AMENDMENT OF SOLICITATION/MODIFICATION OF CONTRACT			1. CONTRACT ID CODE N/A		PAGE OF PAGES 1 70
6 ICCLIED BY	3. EFFECTIVE DATE SEP. 03, 2004	4. REQUISITION/PURCHAS N/A		SPEC. 1	NO. (If applicable) NO. 1406
DEPARTMENT OF THE ARMY U.S. ARMY ENGINEER DISTRICT, SACR SACRAMENTO, CALIFORNIA 95814-2922	7. ADMINISTERED BY (If other than Item 6) DEPARTMENT OF THE ARMY U.S. ARMY ENGINEER DISTRICT, SACRAMENTO SACRAMENTO, CALIFORNIA 95814-2922

14. DESCRIPTION OF AMENDMENT/MODIFICATION (O. California Army National Guard (CAARNG) Readiness Center Lancaster, California	0 - 2	s, including solicitation/contrac	t subject matter where fe	asible.)	
2 Encl.					
 Revised Pages: List of Drawing and Specing 02230-1,02260-1,02300-1,02300-3,0274 09310-3,09511-4,09511-5,09680-1,09912 Revised Drawings: T000, C101, C102, C103 S302,S303,S306,S410,S412,S413,S414,S414 	1-8,02751-6,033000-4, 2-2,10200-3,10505-6,1 ,C110,A004,A005,A2	03470-3,05310-1,0811 5515-6,15839-2,15839 12,S100,S101,S110,S1	(0-3,08331-5,084) 9-3,15900-3,15900 111,S211,S220,S2	11-4,09260- 0-5	3,09310-2,
Except as provided herein, all terms and conditions of th and effect.	e document referenced in Ite	m 9A or 10A, as heretofore	changed, remain

Drawn By: Checked By: **S306**

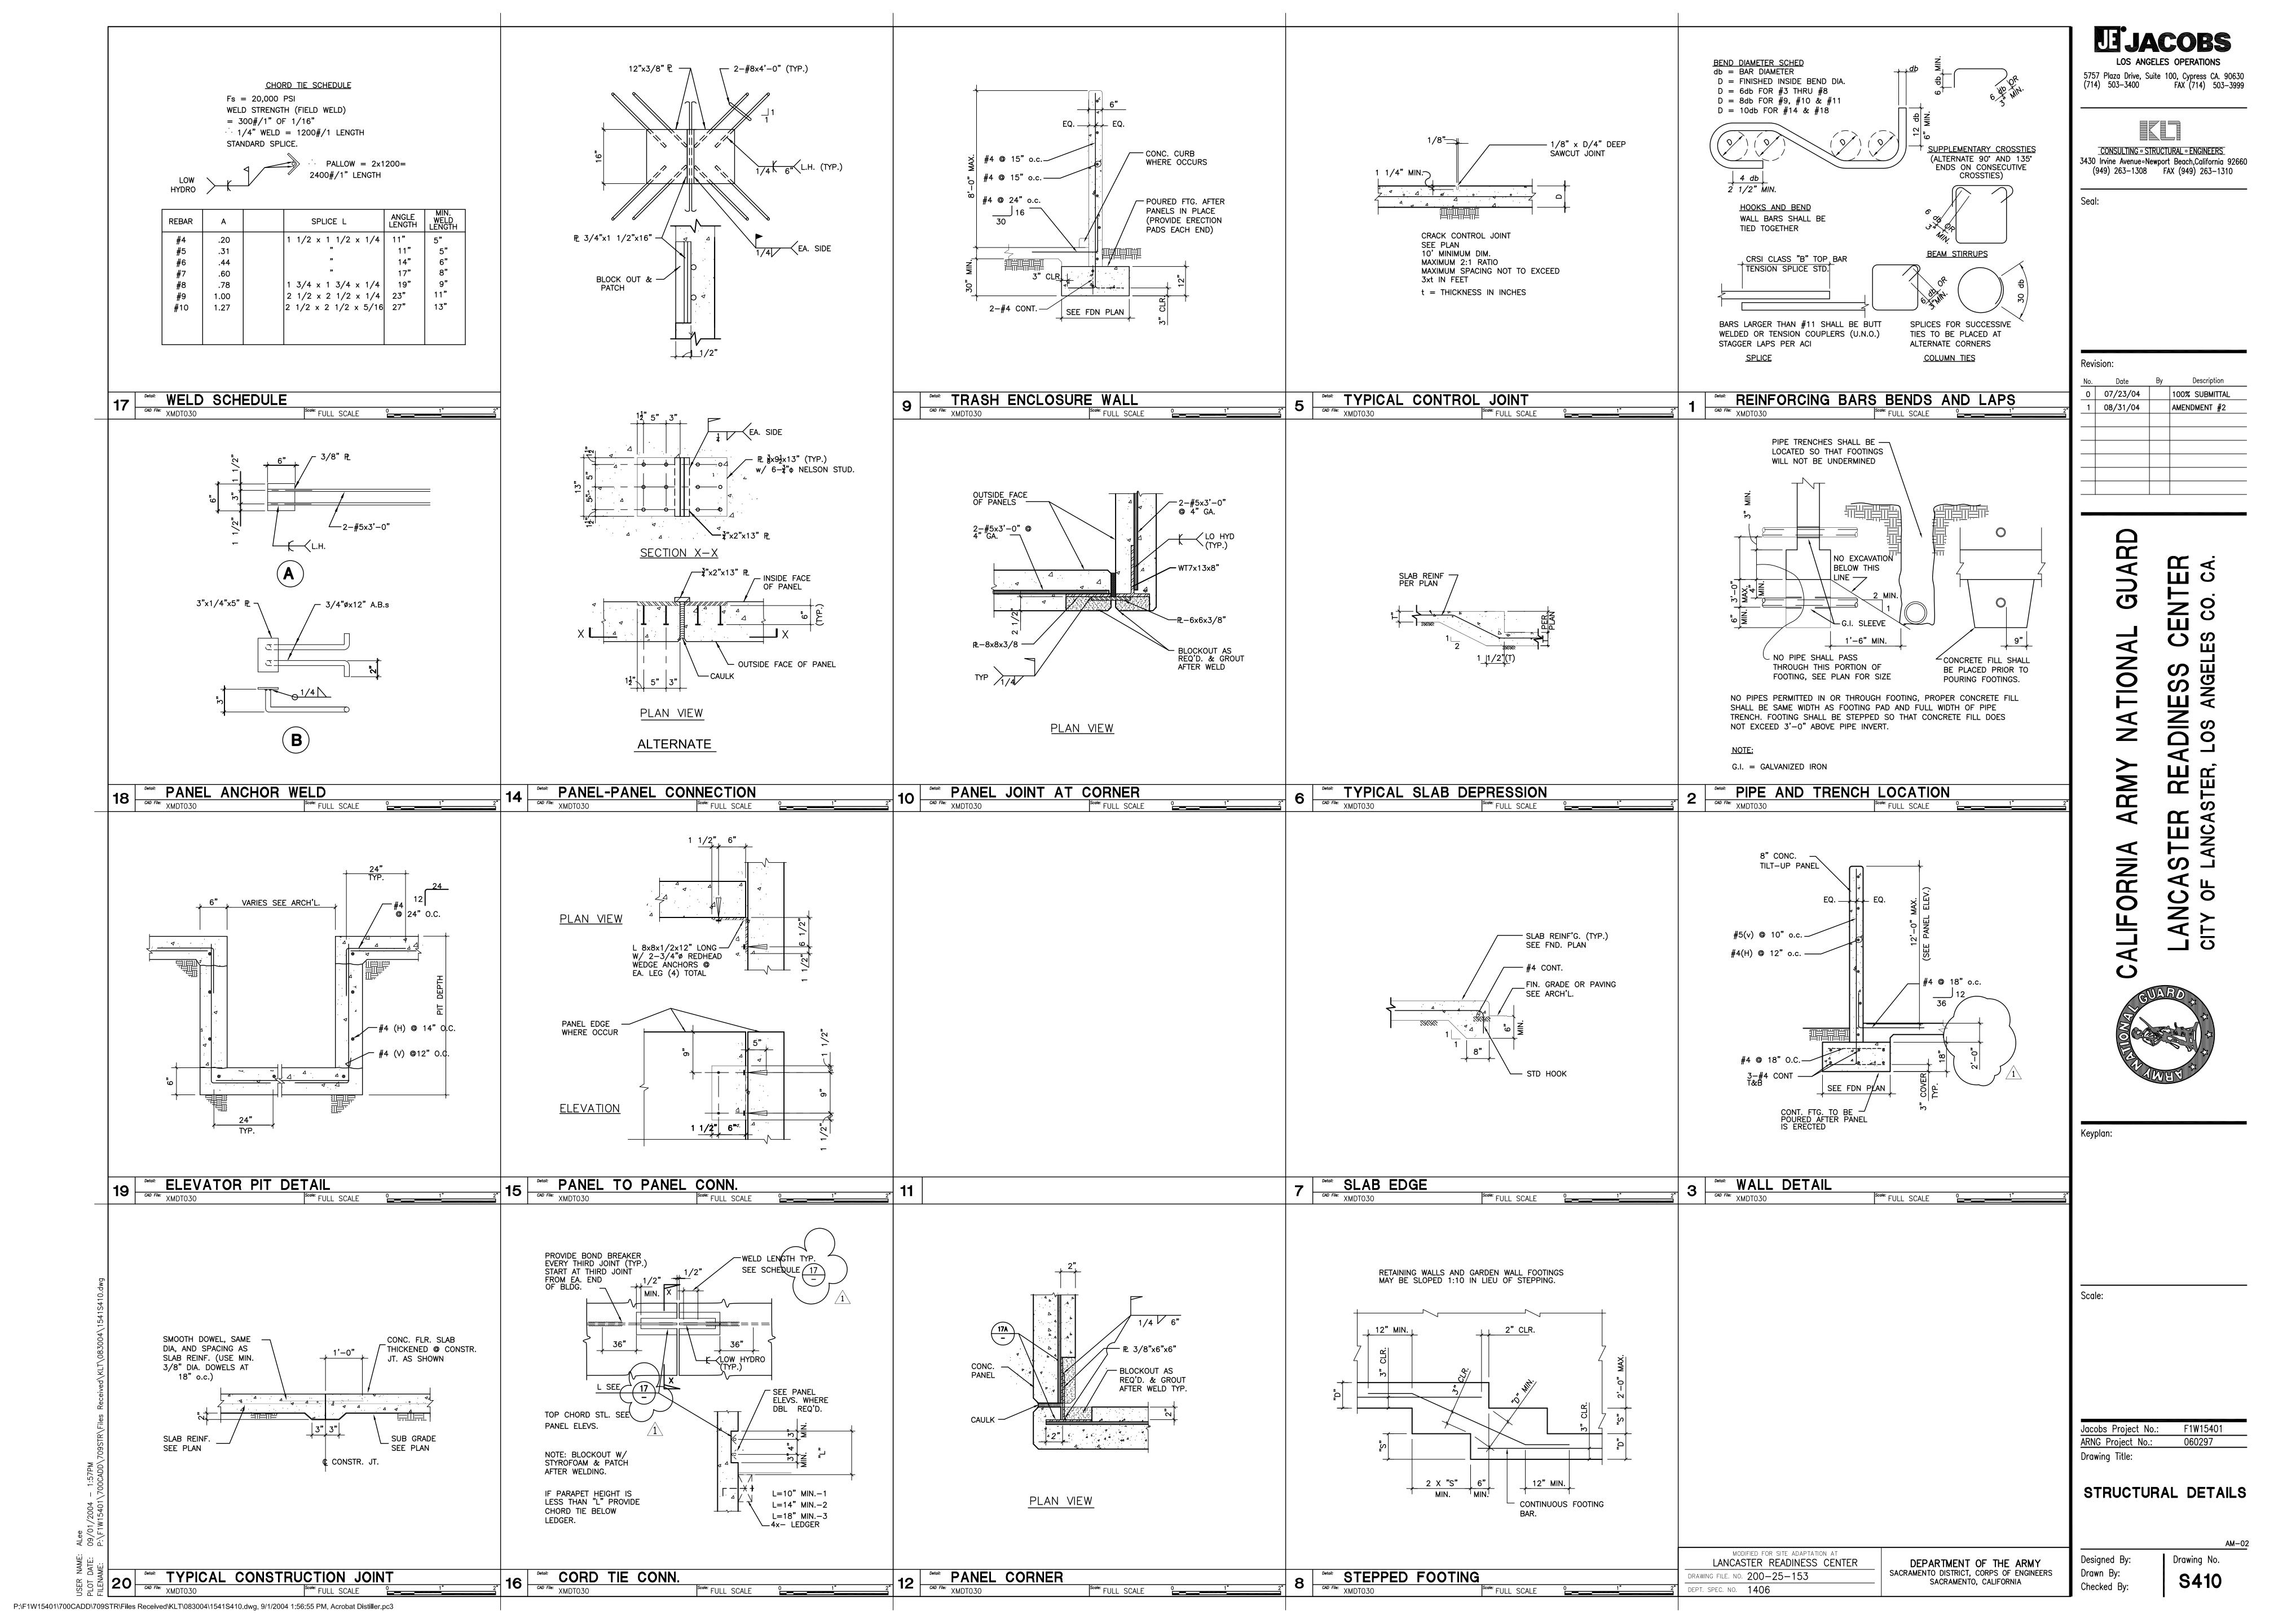
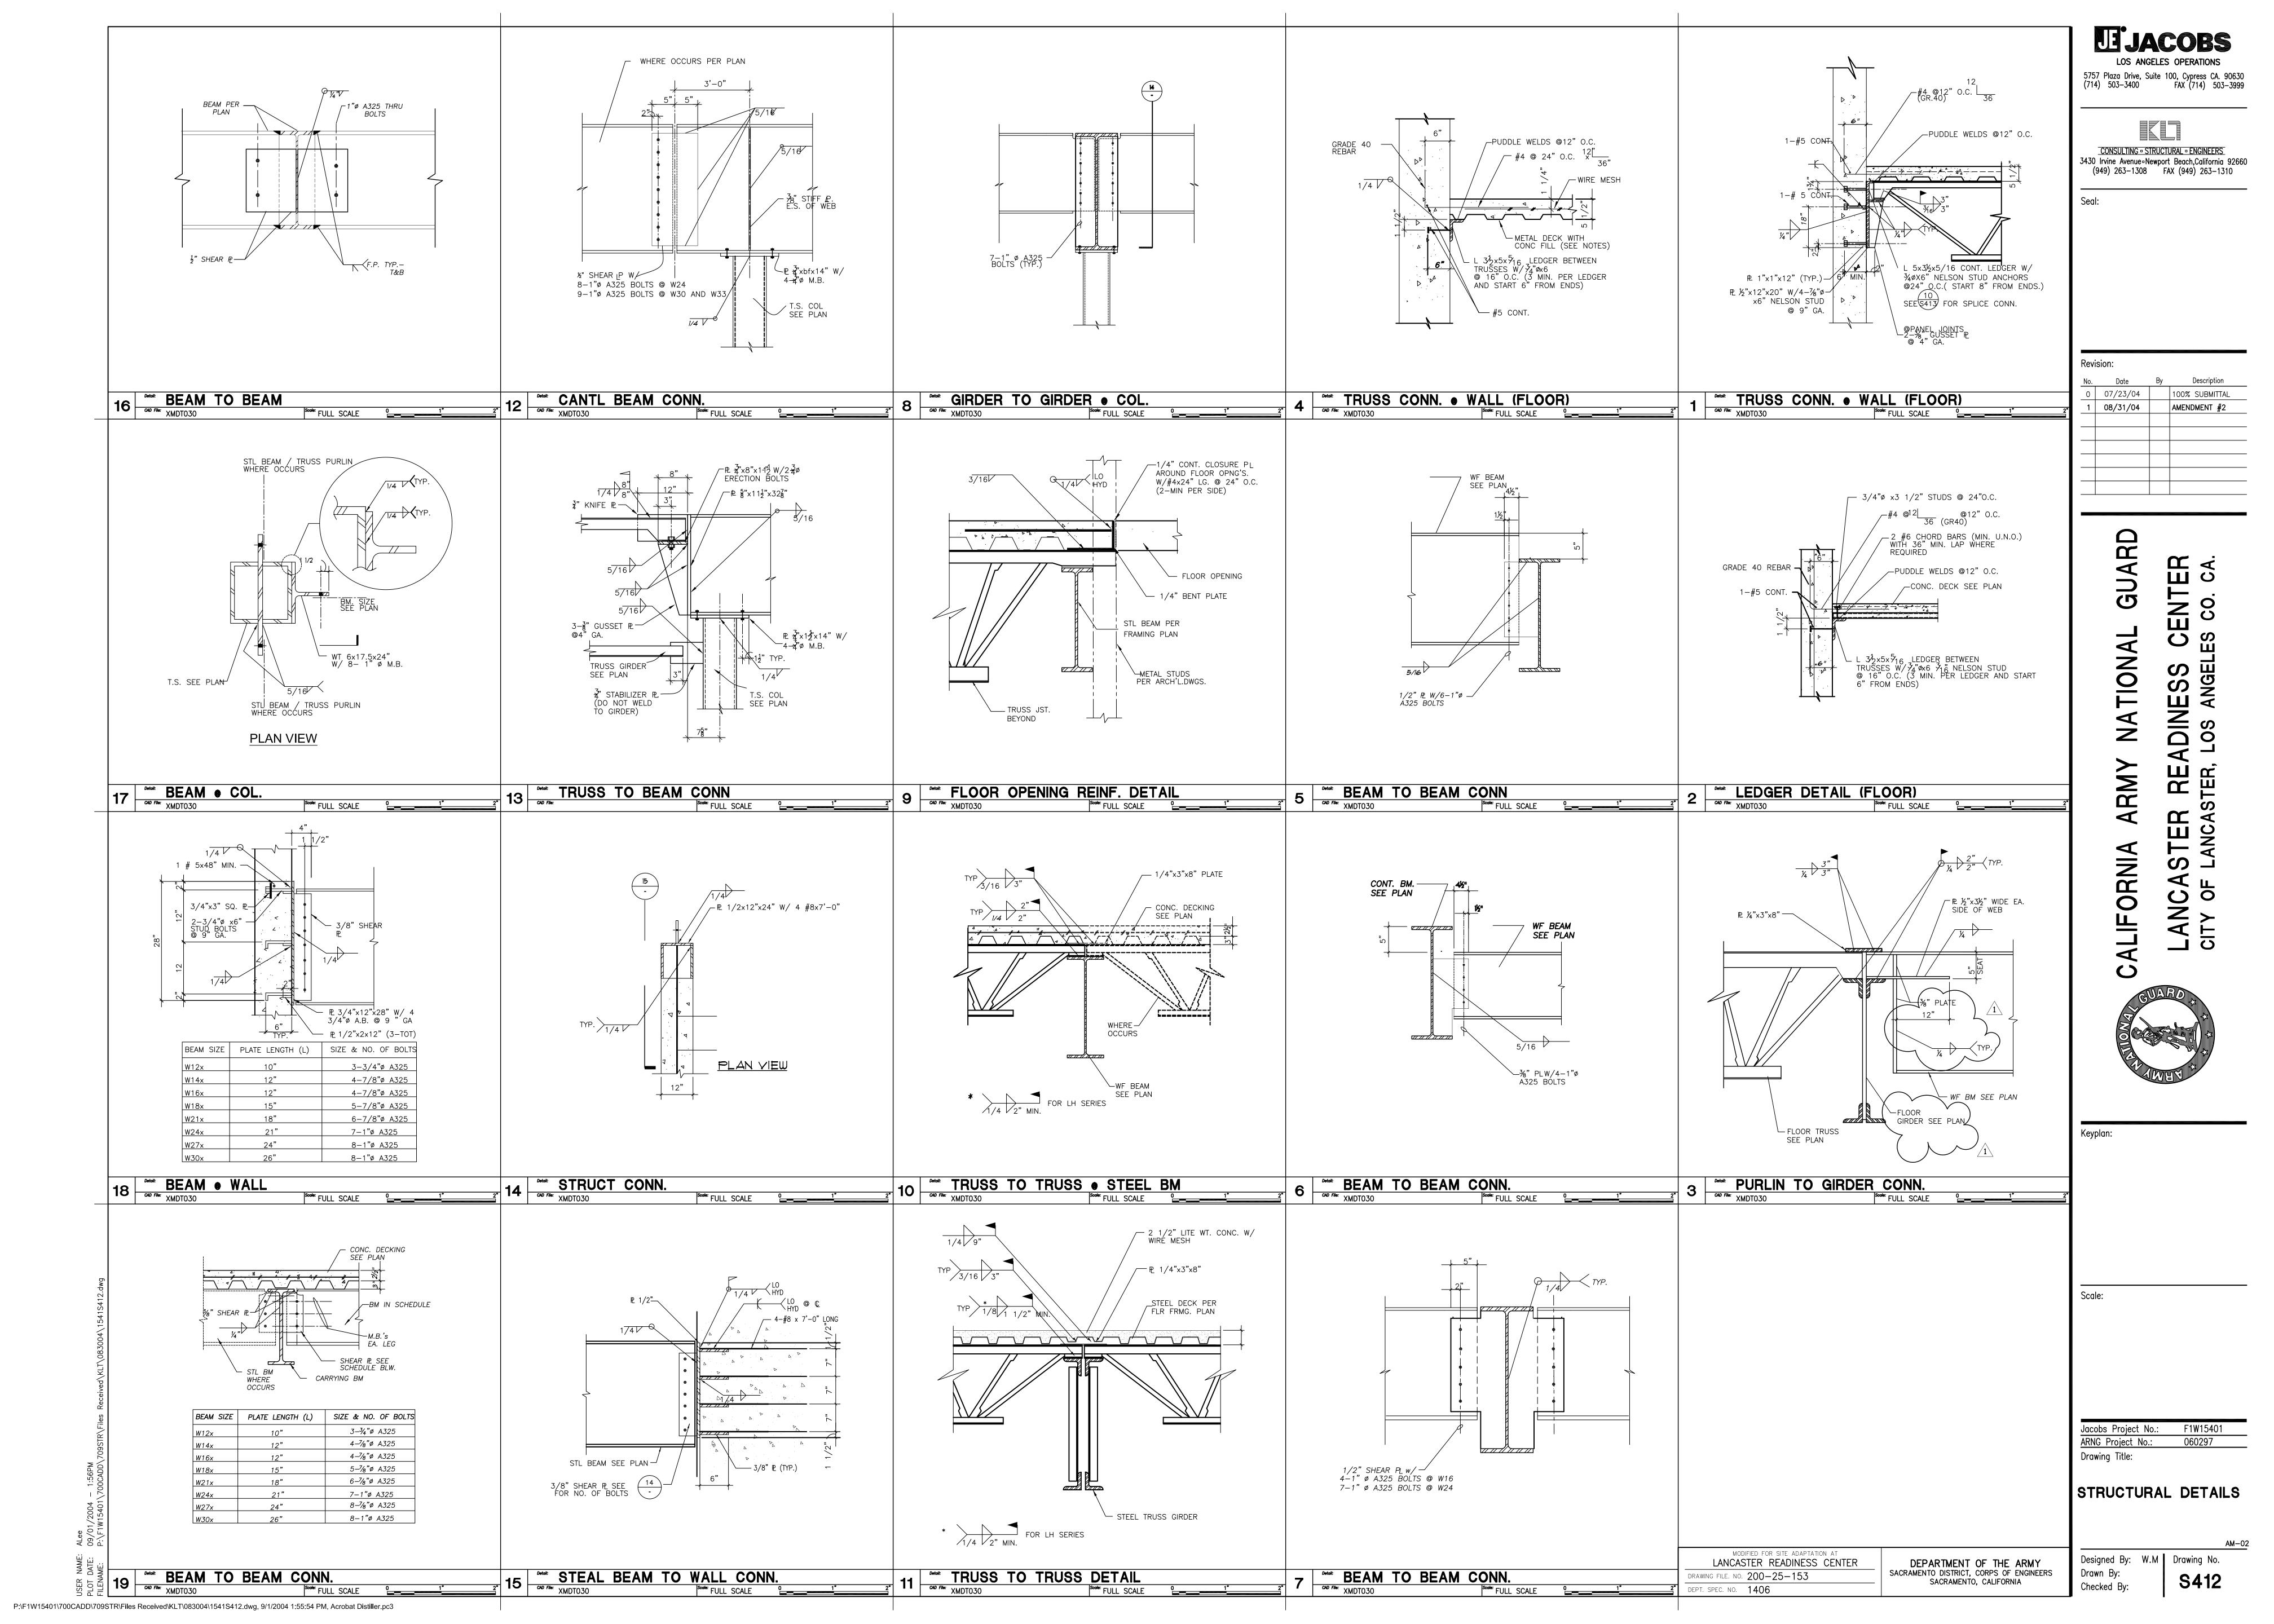
S302	Wall Panel Elevation	Revised a detail callout
S303	Wall Panel Elevation	Revised two detail callouts
S306	Wall Panel Elevation	Revised panel dimensions
S410	Structural Details	Added dimension on detail #3; Revised detail callouts in detail #16
S412	Structural Details	Detail #3 added weld symbol & revised note
S413	Structural Details	Detail #2 and 7 added note; Detail #9 and 13 deleted note; Detail #14 revised note; Detail #16 & 18 revised detail callout
S414	Structural Details	Detail #2 and 3 revised detail callout; Detail #7 added dimension; Detail #9 and 17 revised note; Detail #14 deleted note; Revised detail #19
S416	Stairs 1, 2, & Roof Access Enclosed Plans & Sections	Revised note in detail # 3 and 5, revised enlarged plan # 8, 9, 10, 11 and 12
03300	Cast-In-Place Concrete	Revised Part 2.2 (F.2)
03470	Tilt-up precast concrete	Revised Part 2.1 (B)
05310	Steel Deck	Add Part 1.2 (2)
